1963 - 1982 Corvette: Chevrolet Service News: Rear Spring Removal Service Update

Subject: Rear Spring Removal
Model and Year: 1968 Corvette
Source: Chevrolet Service News
Page Number: NA
Date: August 1968

Revise the procedure appearing on page 4-20 of the 1968 Passenger Car Chassis Service Manual covering Corvette Rear Spring Removal as follows:

Fig. 6—Removing Corvette Rear Spring

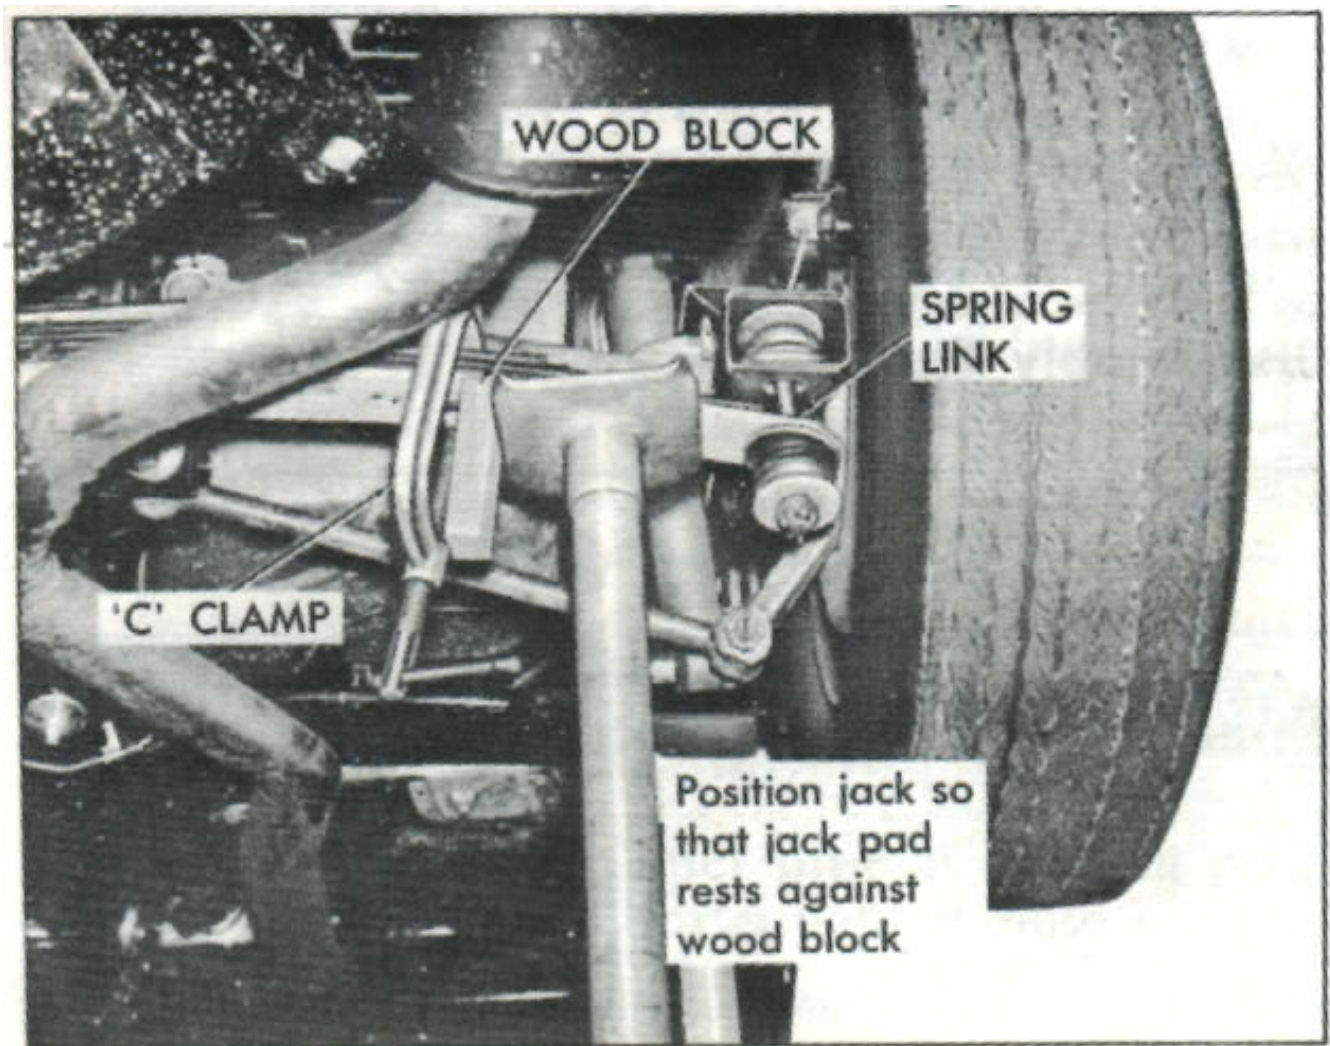
Removal (Reference Fig. 6)

1. Raise rear of vehicle at frame.
2. Install "C" clamp on spring approximately 9" from one end. Tighten securely.
3. Place floor jack under spring with lifting pad of jack inboard of link bolt near the "C" clamp. Place a suitable piece of wood between jack pad and "C" clamp screw. *NOTE - The "C" clamp is merely acting as a 'stop' so that the jack won't slip when the spring is released. The wood block is used to protect the "C" clamp threads from being distorted due to contact with the jack pad.*
4. Raise jack until all load is off link. Remove link cotter key and link nut. Remove cushion.

5. Carefully lower jack until spring tension is released.
6. Repeat steps 2-5 for other side.
7. Remove four bolts and washers securing spring center clamp plate (reference Fig. 51 in Manual).
8. Drop spring and slide out from under vehicle (reference Fig. 51 in Manual).
9. To install, reverse Removal steps 1-8.
